# 42 Honeysuckle Drive

State Significant Development (SSD-10378)

DEVELOPMENT MODIFICATIONS

March 2022

# 5.1 Design Changes South Elevation

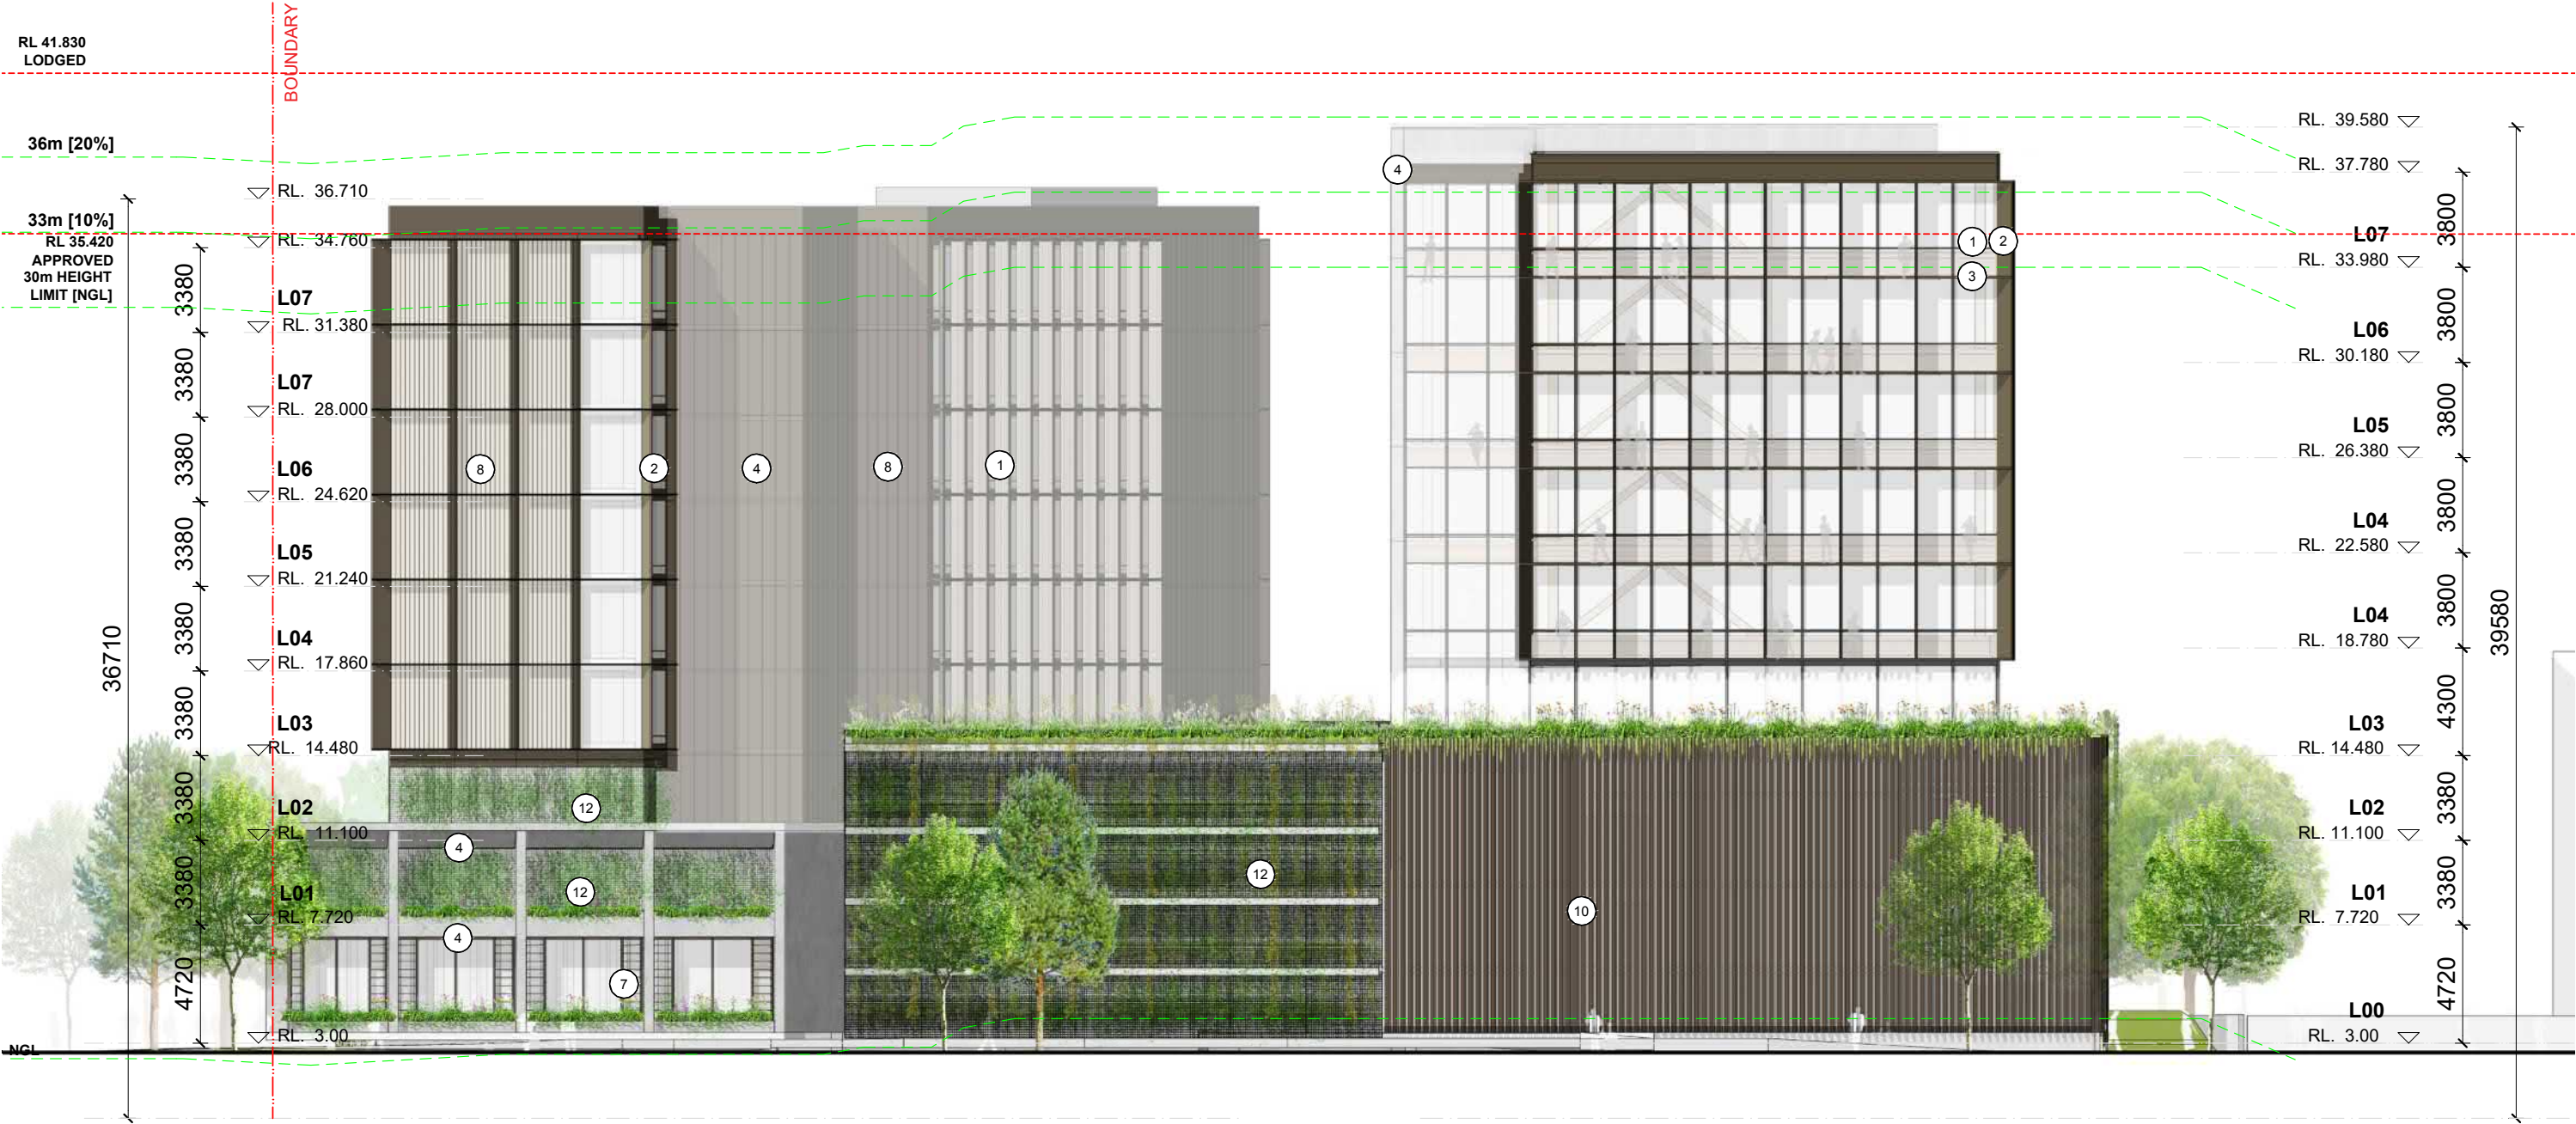
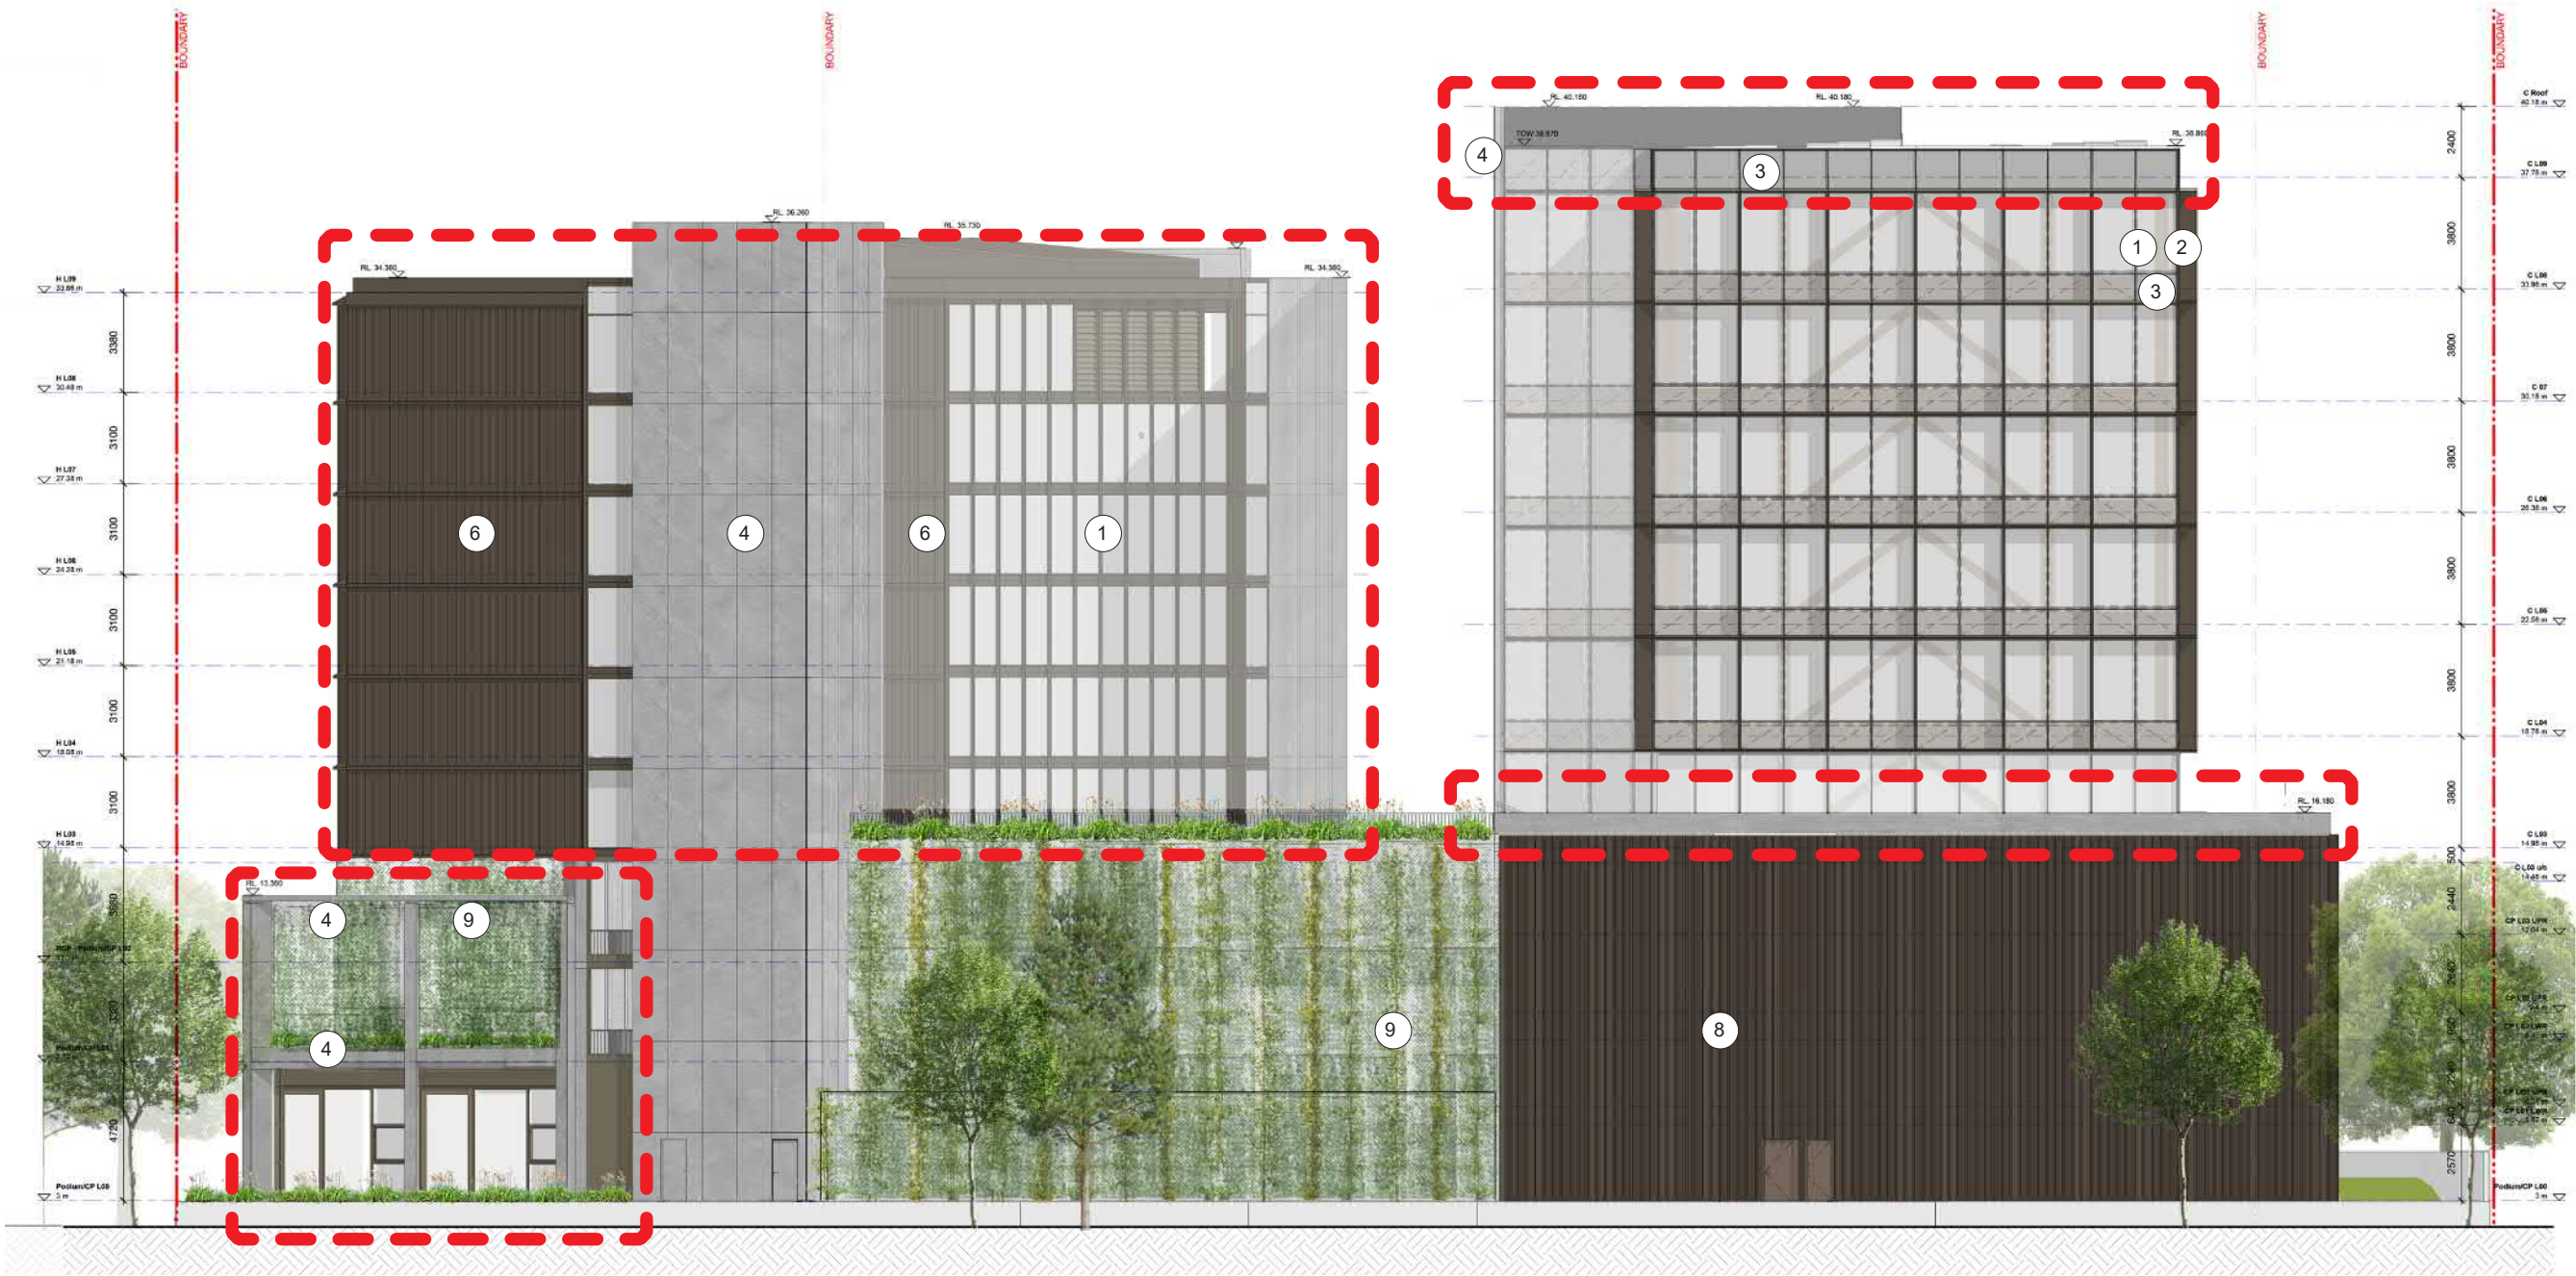
- 1 / Commercial tower height increased by 600mm to allow for additional plant height.  
2 / Perimeter edge planters to Level L03 omitted  
3 / Hotel slab to slab levels reduced from 3380mm down to 3100mm. This has resulted in an overall hotel building height reduction.
- 4 / Hotel south end of building has been reduce in length by 1 hotel room width.  
5 / Arbor structure has been pulled back at the south boundary.  
6/ With the exception of the south west hotel corner elevation the facade colours and materiality remain the same
